STAFF REPORT

SUBJECT: H-2021-0037
DaVinci Park Drive-Through – CUP

LOCATION: 4744 N. Park Crossing Ave. (Lot 11, Block 3, Da Vinci Park Subdivision), in the NE ¼ of Section 31, Township 4N., Range 1E.

A. Proposed Site Plan (dated: 11/20/2021)

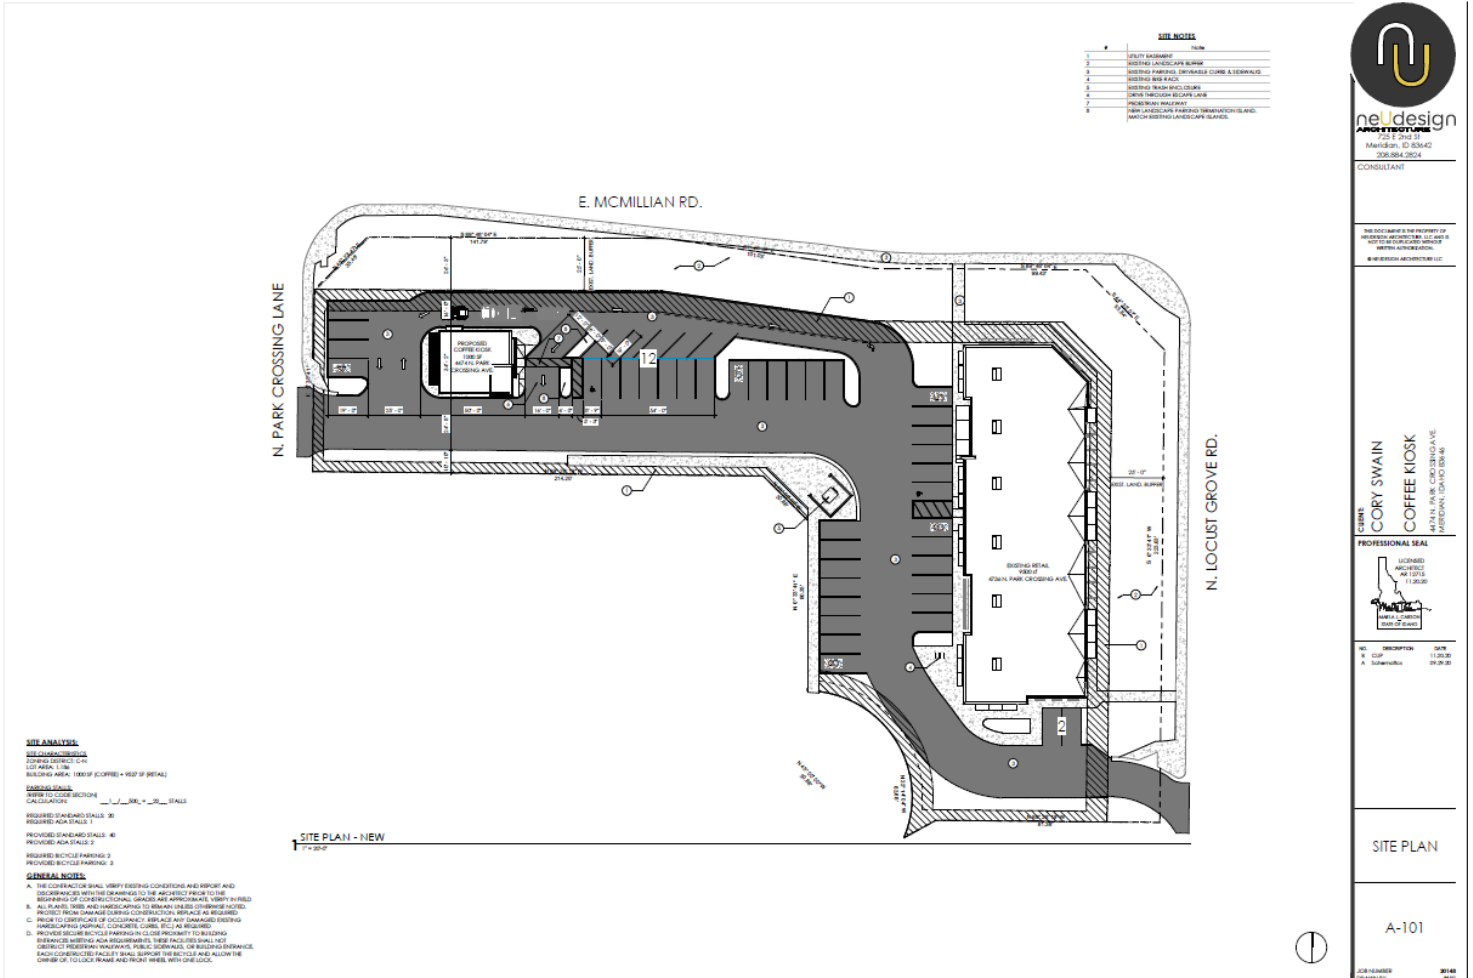
The width of the area proposed for the one-way drive aisle for access to the northern row of parking and stacking lane for the drive-through is too narrow to accommodate both travel lanes – vehicles in the stacking lane will encroach into the drive aisle. Staff recommends the northern row of parking is removed and a planter island is added to guide traffic to avoid conflicts.

The stacking lane and escape lane should be clearly delineated. The northern row of parking adjacent to the stacking lane should be removed.

The stacking lane exceeds 100' in length and an escape lane is proposed that should be signed accordingly.

- f. Remove the northern row of parking adjacent to the stacking lane and install signage for the escape lane. Depict a planter island along the northern side of the remaining row of parking to guide traffic, landscaped per the standards in UDC 11-3B-8C.

- g. Clearly delineate the vehicle stacking lane for the drive-through and the escape lane.
3. Direct access via E. McMillan Rd. is prohibited.
4. Compliance with the standards listed in UDC [11-4-3-11](#) – Drive-Through Establishment is required.
